Gunstfontein Wind Energy Facility and associated infrastructure, Northern Cape Province

Motivation for amendment of Environmental Authorisation

DEA Ref.: 14/12/16/3/3/2/826

May 2019

Figure 7: Comparative Viewshed Analysis – Gunstfontein Wind Energy Facility.

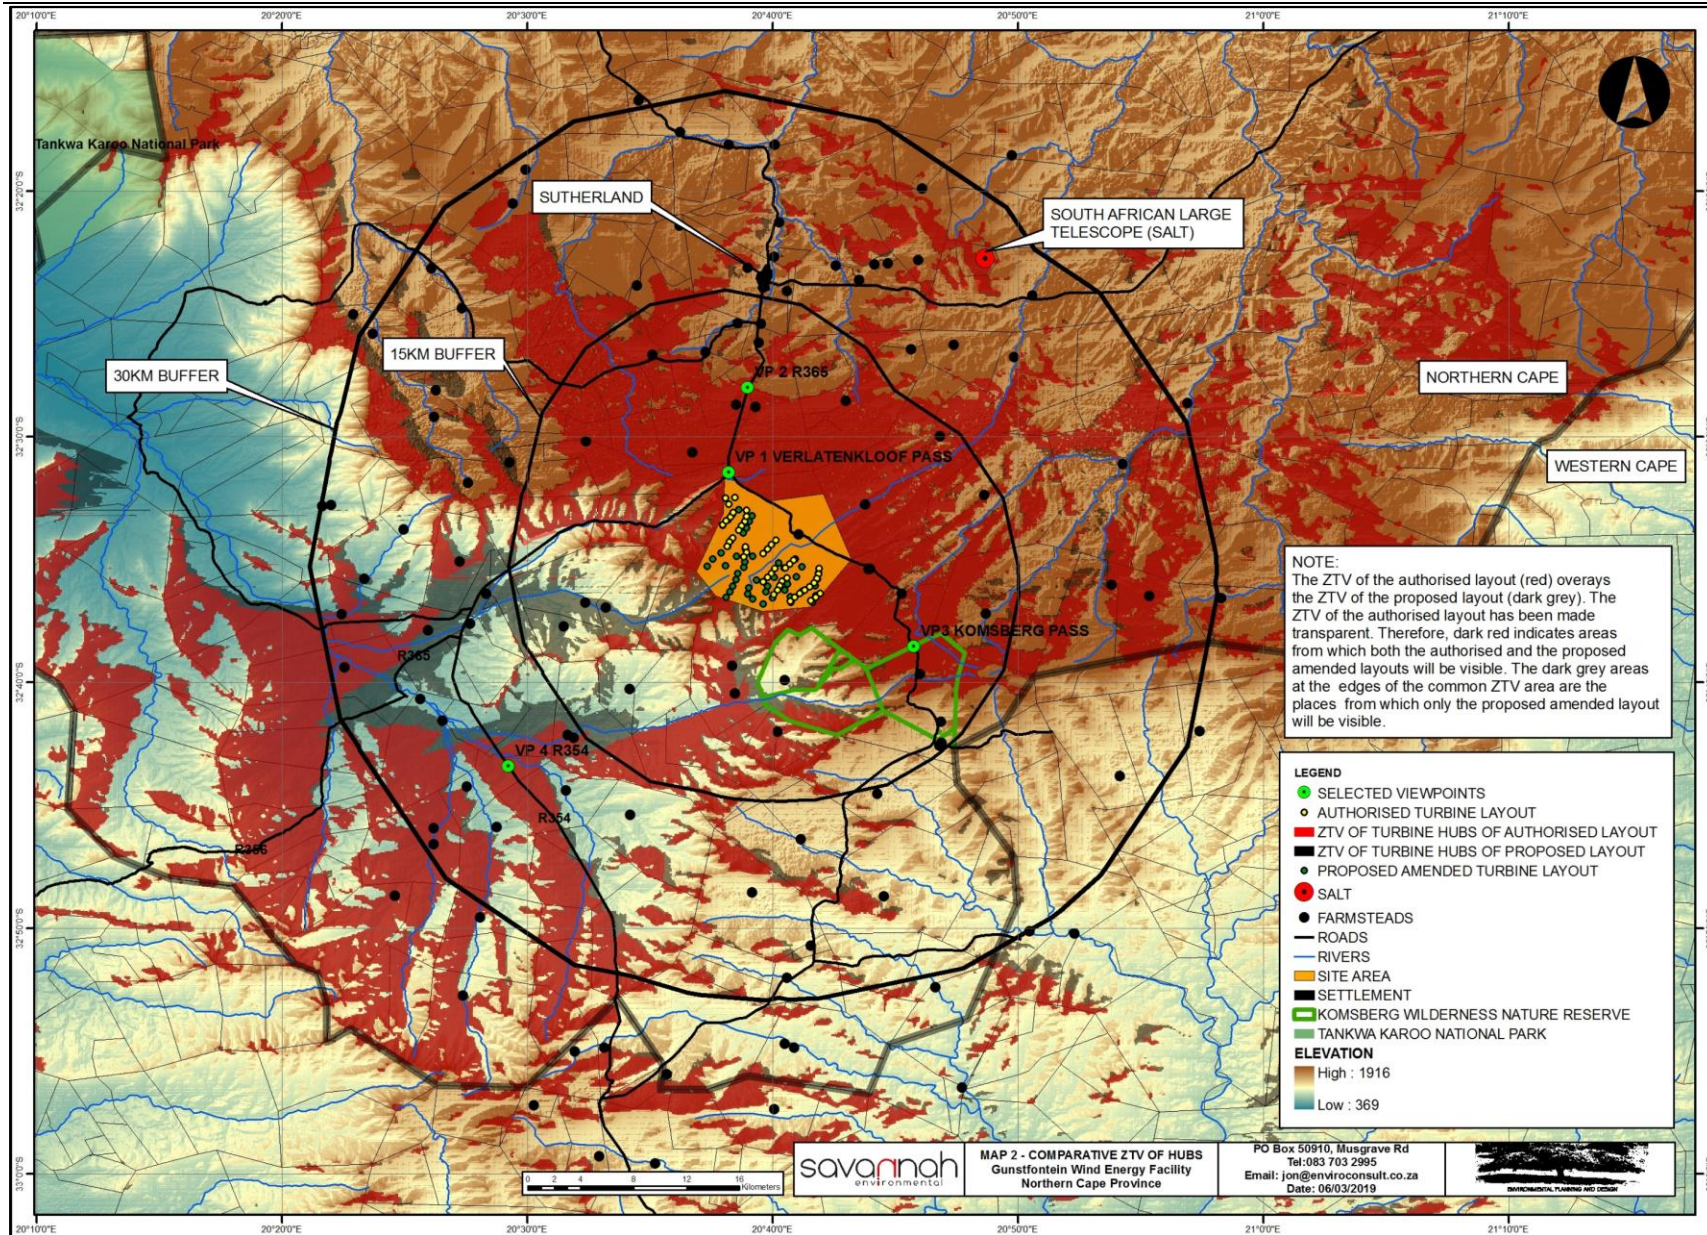
- » **VP1 (Figure 5.7) Verlatenkloof Pass:** The turbine structures used in the proposed amended layout are approximately 25% taller than those proposed in the authorised layout, due to the fact that the closest structure is approximately 2.9km (proposed amended layout) from the viewpoint as opposed to 1.9km (authorised layout), the apparent height of the structures due to this increased difference is noticeably lower. This indicates that the proposed development layout is likely to result in a reduced visual impact from the top of Verlatenkloof Pass and the closest sections of the R354 when compared with the authorised layout.

- » **VP2 (Figure 5.7) the R354:** This is one of two main routes into and out of the town of Sutherland and is approximately 6.5km to the north of the project site. The additional height associated with the proposed amended layout is not highly obvious when compared with the authorised project. Visual impact on this section of road is therefore not likely to increase to any significant degree therefore.

- » **VP3 (Figure 5.7) un-surfaced road that runs down the Komsberg Pass:** This road is 7.2km to the east south of the site. The additional height associated with the proposed amended layout is not highly obvious when compared with the authorised project and the proposed amended layout does extend over a marginally wider section of the landscape when compared with the Authorised Layout. From this area therefore the proposed project is likely to have a marginally greater level of visual impact.

- » **VP4 (Figure 5.7) this viewpoint is approximately 18.5km to the south west on the R354 and within the Buffels River Valley.** From this viewpoint the additional height of structures is not highly obvious. It is obvious that the proposed amended layout will result in a greater number of turbine structures visible when compared with the authorised layout. This is likely to be largely due to the proposed amended layout resulting in turbines being located approximately 3km closer to the edge of the Komsberg ridgeline when compared with the authorised layout.

From review of Figure 5.7 which indicate the approximate number of turbines that are likely to be visible from each area, it appears that approximately 9 – 10 proposed turbine locations are responsible for creating this additional impact. The possible relocation of turbines in order to minimise this additional impact has been discussed with the Applicant. However, it has been confirmed that because the larger turbines require more space between them to reduce internal wake effects they have to be spread across the previously assessed footprint.

Figure 5.6: New locations of wind turbines compared with old layout.

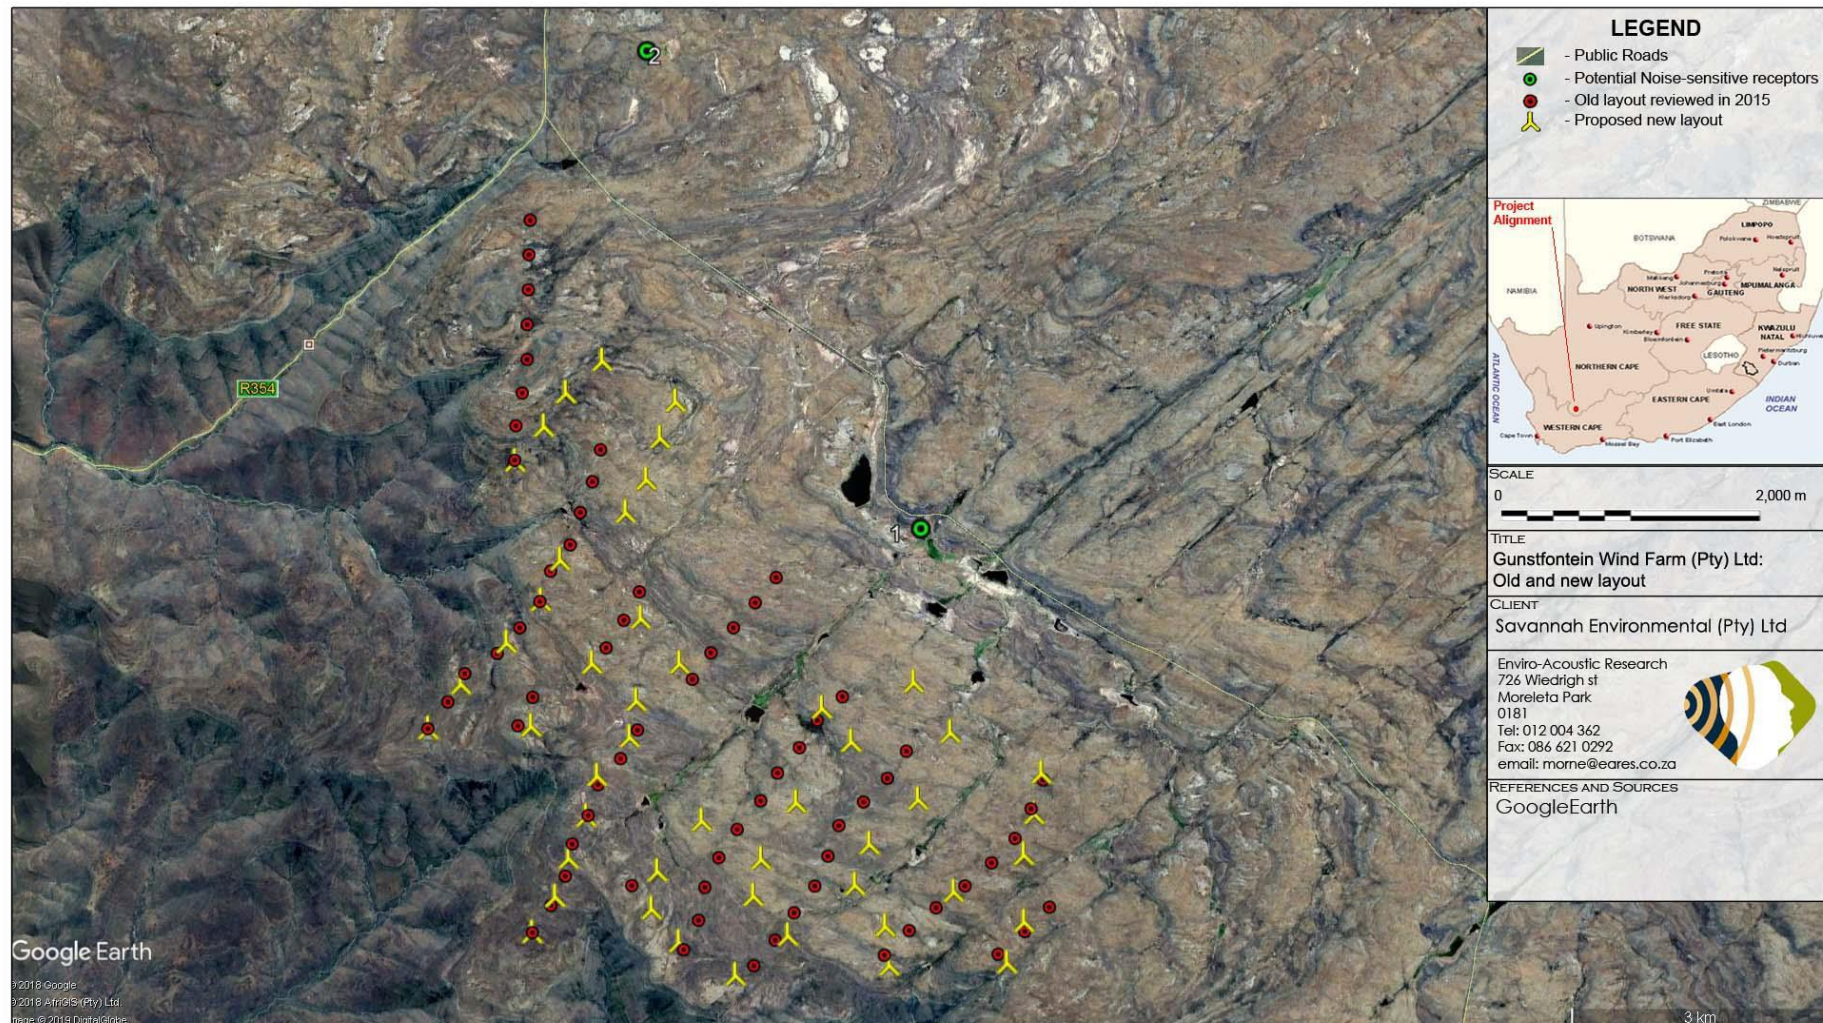
An optimized layout is proposed for the Gunstfontein Wind Farm, designing the wind turbines at optimal locations (see Figure 5.8). The change however does not move any wind turbines closer than 1 000 m from any potential noise sensitive developments (NSDs), with the closest wind turbine located more than 1 700 m from the closest NSD. Considering the location of the wind turbines and the potential noise impact, it is the opinion of the specialist that the change will not increase the significance of the noise impact.

Figure 9.1: Updated wind farm layout with specialist environmental sensitivities (A3 Map included in **Appendix H**)

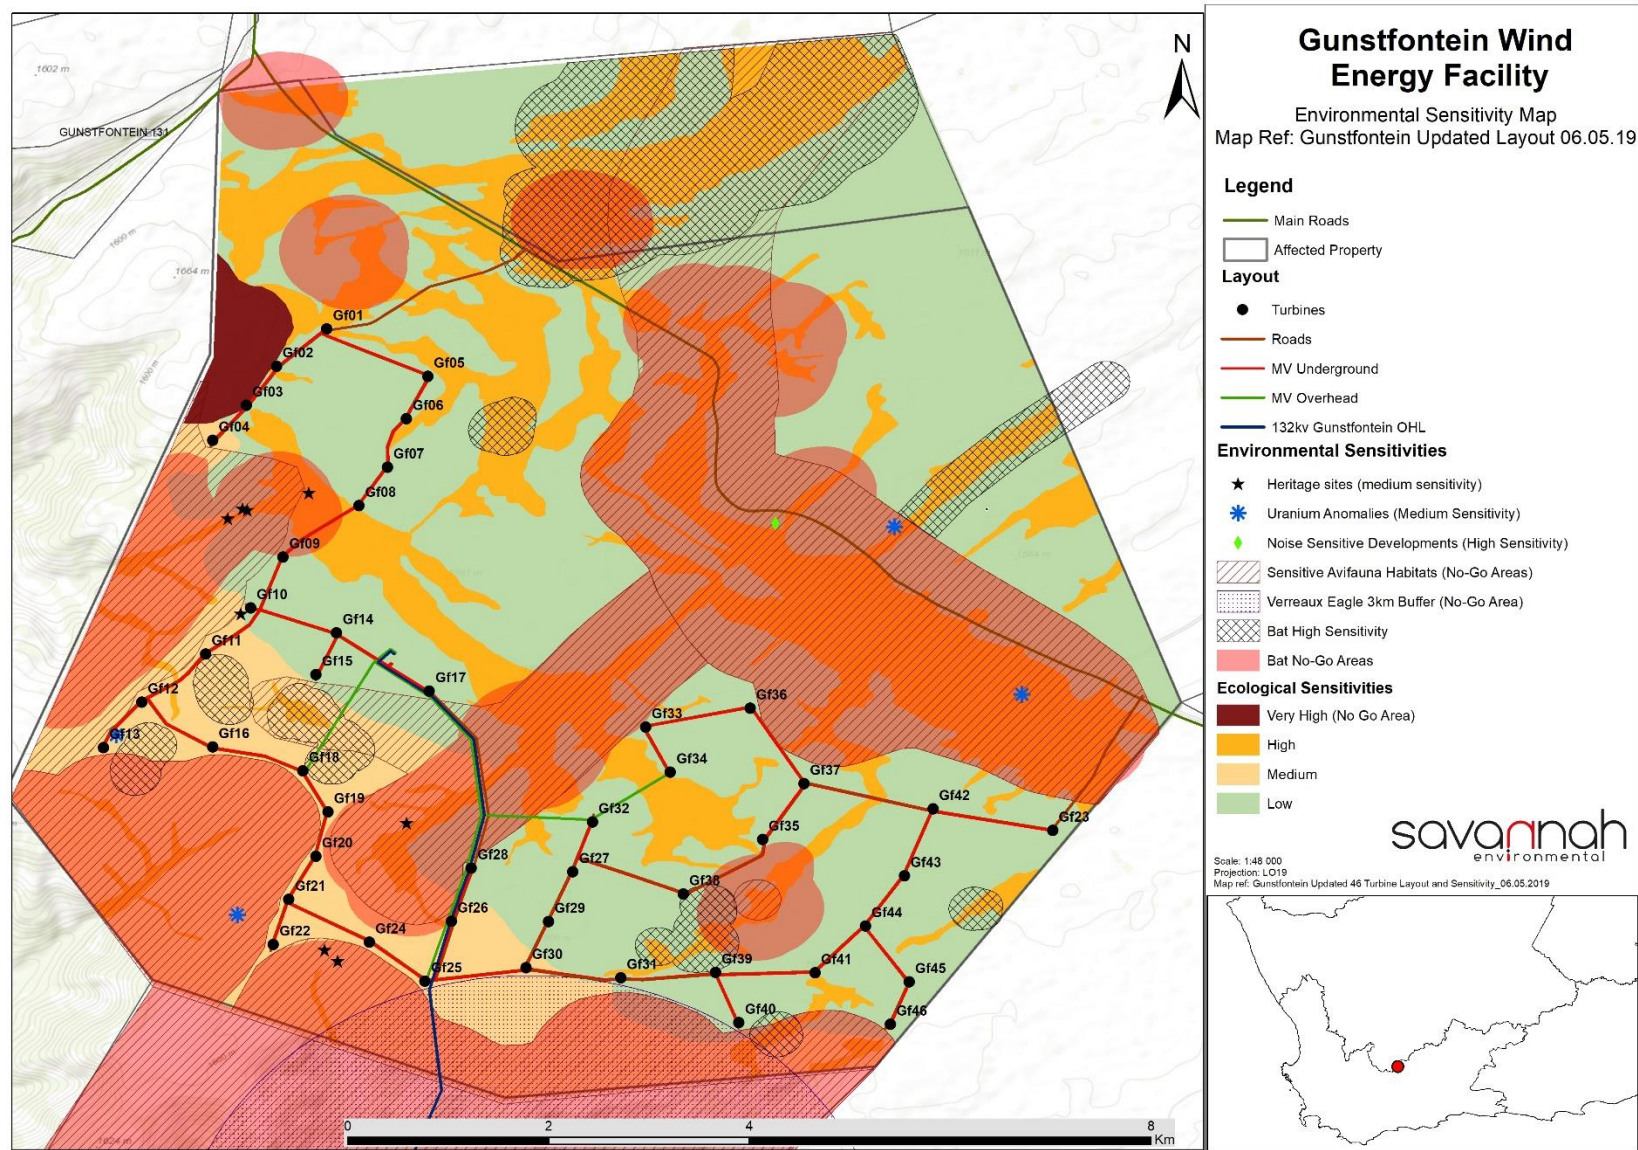
In addition, the amended wind turbine positions considered avoids all identified avifaunal exclusion zones and areas of high sensitivity (refer to Figure 9.1). An operational-phase bird monitoring programme was also recommended by the avifaunal specialist (in line with the guidelines applicable at the start of the operational phase).
